10/551,167

Office Action Summary

LANDRIEVE, FRANCK

DETAILED ACTION

Figure 1

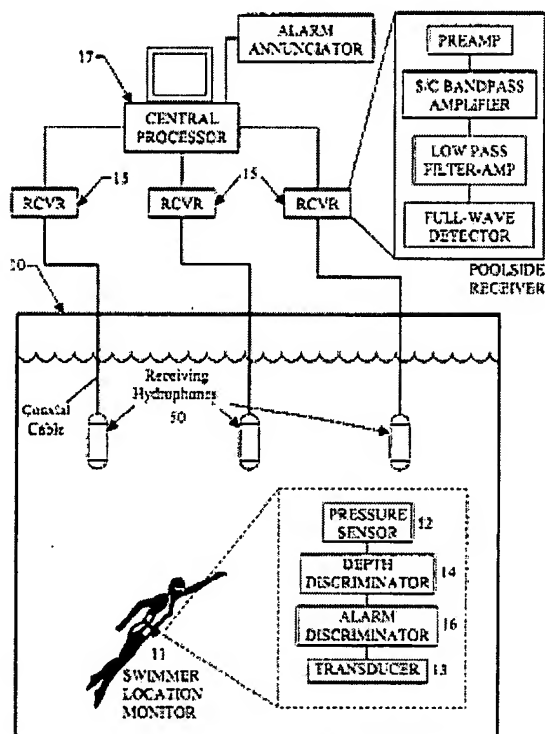
Miller describes a portable measuring instrument (fig. 1, unit 11), particularly for use in sport (fig. 1), comprising: a housing (fig. 1, unit 11) comprising: a sensor (fig. 1, unit 12); a receiver (fig. 1, unit 12); a transmitter (fig. 1, unit 13); and a processing unit (fig. 1, unit 14, 16); wherein the housing is adapted to transmit signals coming from the sensor to the housing intended to be worn by a user (fig. 1, unit 11), and wherein the housing functions as a relay by receiving signals coming from a remote detector intended to be worn by a user (col. 2, lines 14-42) and retransmitting these signals to the housing (fig. 1, unit 11, 50, 12, 13).

Regarding claim 7, Miller further describes remote display comprising a display screen (fig. 1, unit 17), a secondary receiver (fig. 1, unit 50).

Regarding claim 8, Miller further describes secondary processing stage (fig. 1, unit 15) able to identify a secondary signal according to a secondary identification code inserted in a frame of the secondary signal (fig. 1, unit 11, signal to 50, col. 4, lines 45-62, detect which signal come from in the pool area with different users).

Regarding claim 9, Miller further describes a sensor (fig. 1, unit 12), a primary transmitter (fig. 1, unit 13).

Regarding claim 10, Miller further describes wherein the detector comprises a processing stage (fig. 1, unit 14, 16) able to provide a primary signal encoding a measurement signal of the sensor and a primary identification code (fig. 1, unit 13, col. 4, lines 45-62, detect which signal come from in the pool area with different users)

Regarding claim 11, Miller further describes detachable fixing components (fig. 1, unit 11).

Regarding claim 14, Miller further describes a sensor (fig. 1, unit 12) and a primary transmitter (fig. 1, unit 13).

Regarding claim 4, Miller further describes a display screen (fig. 1, unit 17).

Miller does not describe fixing display directly on the user. Miller does show the display (fig. 1, unit 17), but it would have been obvious to one having ordinary skill in the art at the time the invention was made to fix display directly on the user since it has been held that rearranging parts of an invention involves only routine skill in the art (In re Japikse, 86 USPQ 70 C (CCPA 1950), in order to have flexibility on a system to view the result anywhere by anyone.

Figure 2

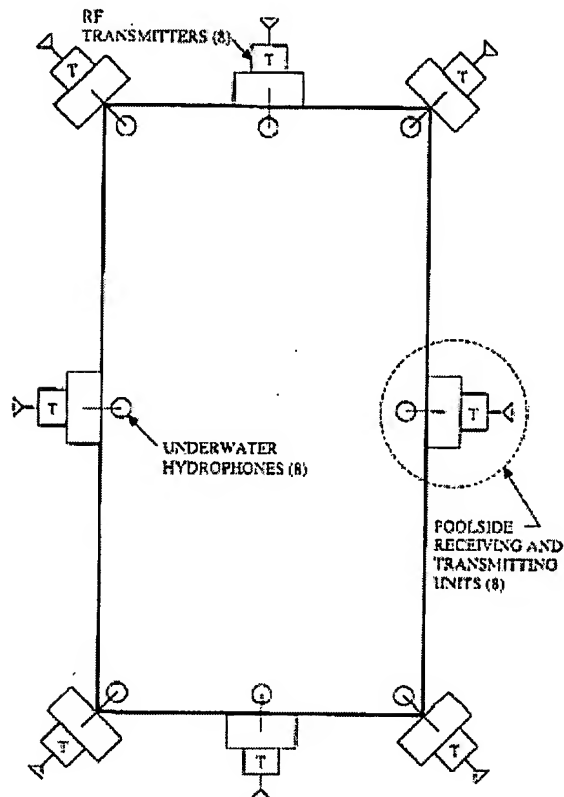
2. The drawings are objected to under 37 CFR 1.84 (o)(n) which requires legends on drawings and labeled representations are used must be adequately identified in the specification, in figure 2, the generic blocks 6, 18, 17, in figure 4, the generic blocks 21, 22, 23, 24, 20, 34, 6, 27, 26, 28, 33, 32, 31, 7 and 30 should be provided with descriptive labels to avoid confusion (e.g. software protocol, transmitter, frequency hopper, receiver, etc), correction is required.
